PROJECT: BASS PRO SHOP
1106 Valley Ave NW, PUYALLUP, WA 98371
1042 Valley Ave NW, PUYALLUP, WA 98371
PARCEL #: 04220163042

DRAWING ISSUED FOR:
AGENCY REVIEW

PLANTING PLAN

DRAWING CONTENTS
LANDSCAPE
DETAILS &
NOTES

LANDSCAPE PLAN

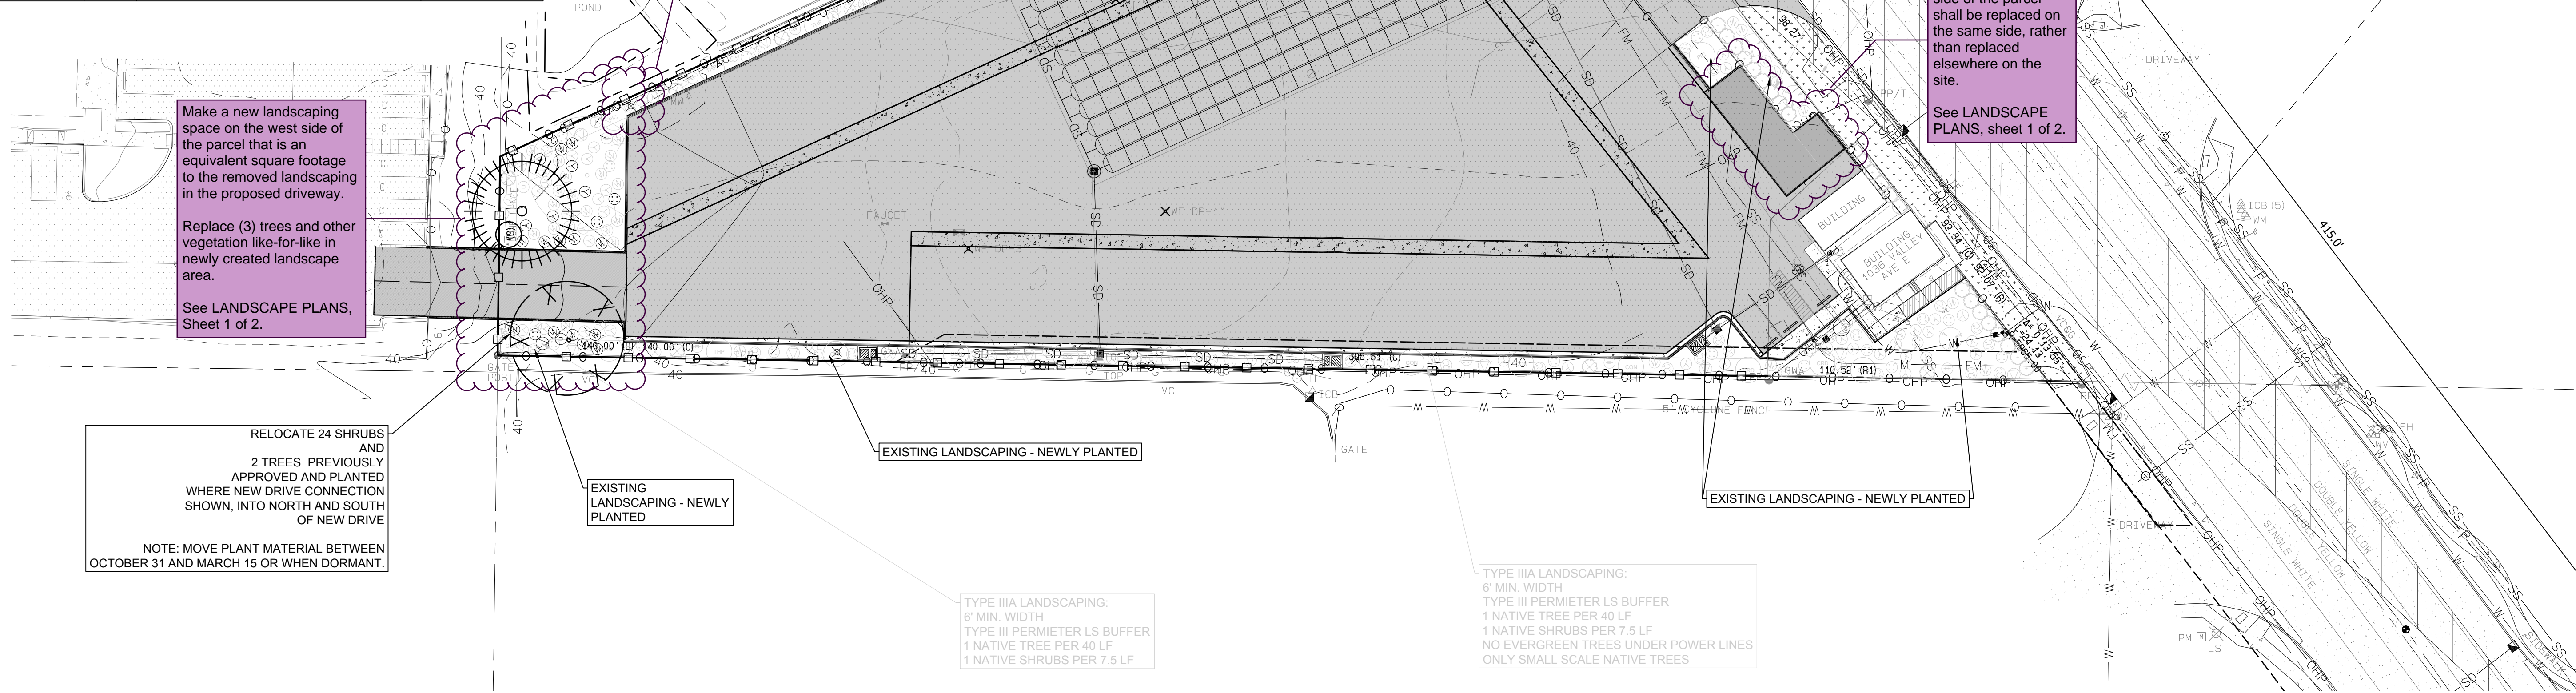
Please refer to page 44 of the VMS (Vegetation Management Standards) for parking lot light pole standards.

Per 14.4, Type IV: Parking Lot Landscaping, Type IV Design Standards (E): "Internal parking lot lighting poles and fixtures shall be located to minimize future conflicts with parking lot trees -- parking lot lights shall be placed 10' from any parking lot tree required under the type IV standard."
